HEARING DATE: February 13, 2025

A-25:007 — 754 Cannon Street East, Hamilton

HEARING DATE: February 13, 2025

Re: 754 Cannon St E

MINIMUM CONDUCTOR CLEARANCES FROM
BUILDINGS, PERMANENT STRUCTURES OR
BUILDING APPARATUS

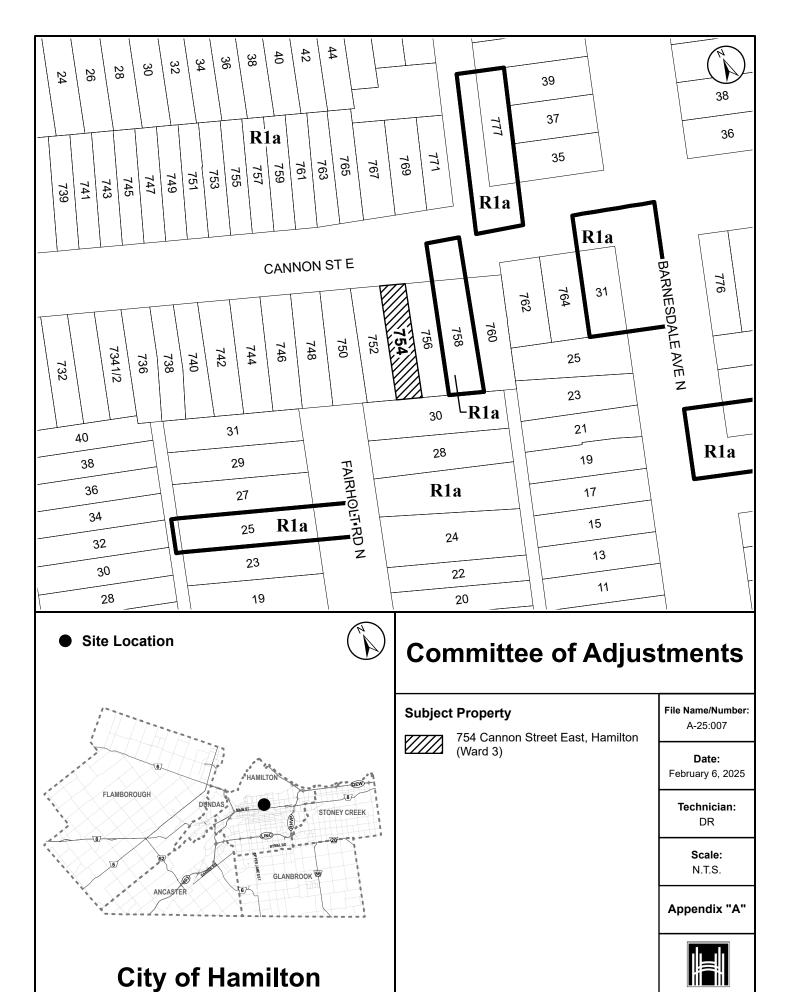
- Minimum 4m horizontal clearance from existing O/H line(s) must be maintained at all times as per Alectra Utilities Standard 3-105. Please consult with Alectra Utilities if further clarification is required.

- Existing O/H secondary service conductor may be in conflict with propossed exterior front egress by being accessable to the public from the landing. Contact our ICI group to discuss new service location and possible service upgrade if required.
